14. DESCRIPTION OF AMENDMENT/MODIFICATION (Organized by UCF section headings, including solicitation/contract subject matter where feasible.)
THE ABOVE REFERENCED SOLICITATION FOR THE LOCKER ROOM RENOVATION AT THE DENVER ARTCC IS AMENDED AS FOLLOWS:

RFO: DTFANM-11-R-00062

Locker Room Renovation at the Denver ARTCC in Longmont, CO

AMENDMENT 0003

ARTCC
LOCKER ROOM RENOVATION
COVER SHEET

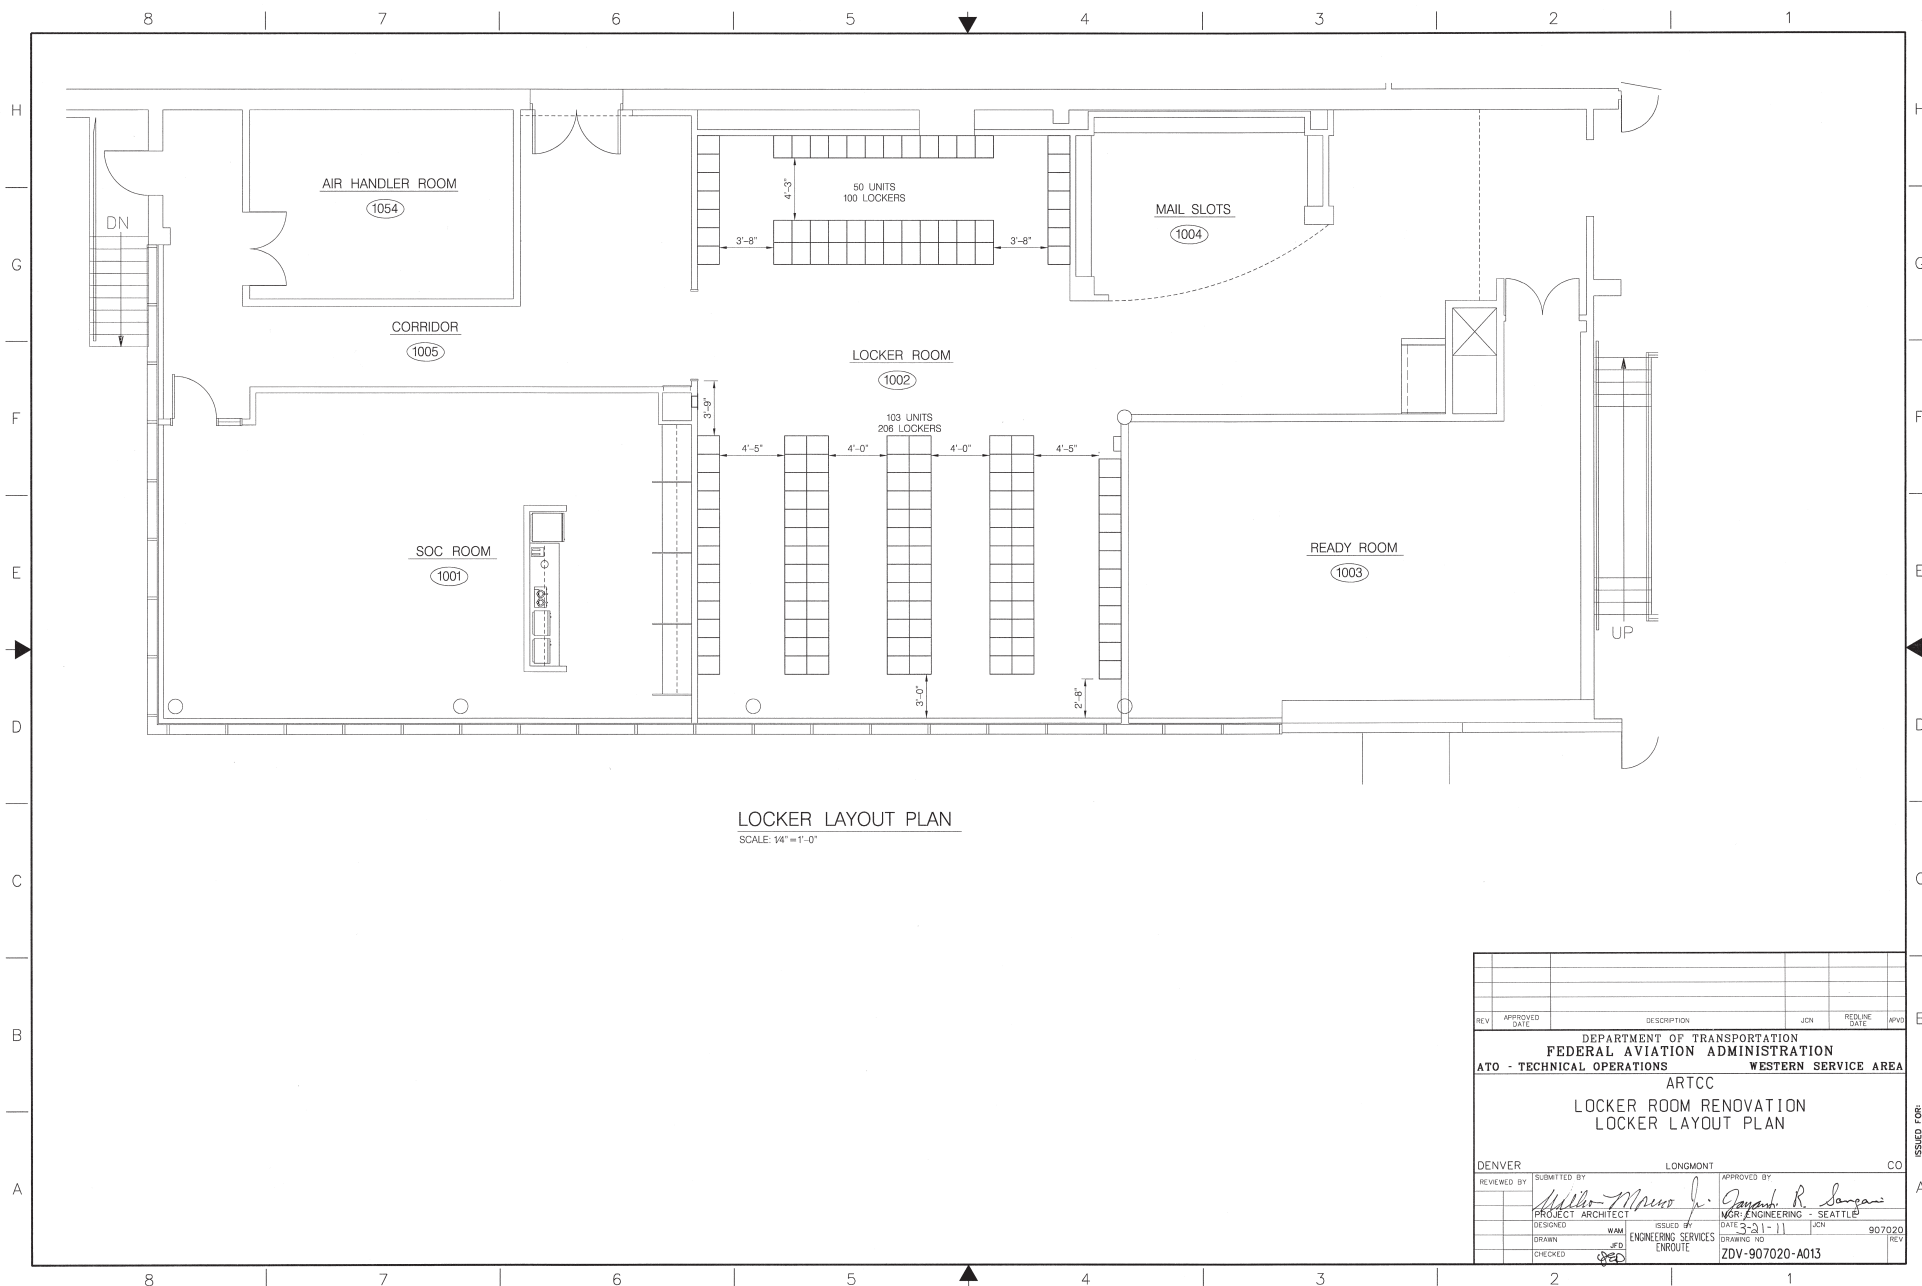
REV	DATE	DESCRIPTION	JCN	RESOLINE DATE	APV
A	3/21/11	ADDED ZDV-907020-A013 TO DRAWING LIST	907020
